19 February 2021

A00.03283-L01-v1.0-20210219.docx

**Property - Tumut  
Independent Review - Flooding**

Figure L2 – Provisional Hydraulic Hazard Categories of the NSW Floodplain Development Manual.

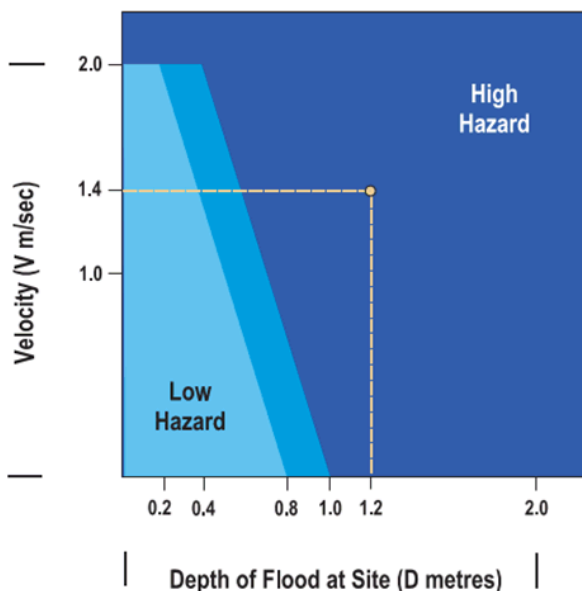
Flood Hazard at the specific building site has been assessed in accordance with Figure L2 – Provisional Hydraulic Hazard Categories of the NSW Floodplain Development Manual (reproduced below)

The estimated 100 year flood level is at RL 264.0. The depth of flood waters at the building site with a floor level of 263.0m would be approximately 1.0m. The 1984 Flood Study provides an estimate of average flood velocities of 0.9m/s across the floodplain. Based on these depths and velocities the site would be a **high hazard** area.

However, at the actual building site location on the edge of the floodplain the velocities would likely be significantly less than 0.9m/s, and based on SLR experience would likely be around 0.5m/s at that specific location. If carpark levels are raised by 0.5m in accordance with SLR’s recommendations (see below), then the flood hazard would be **low hazard**. (depth 0.5m, velocity 0.5m)

With consideration to the LEP and flood hazard it is recommended that the carpark level be raised by 0.5m.

⇒ **It is recommended that floor levels of the proposal be amended as follows:**

- **carpark raised from RL 263.0 to RL263.5**
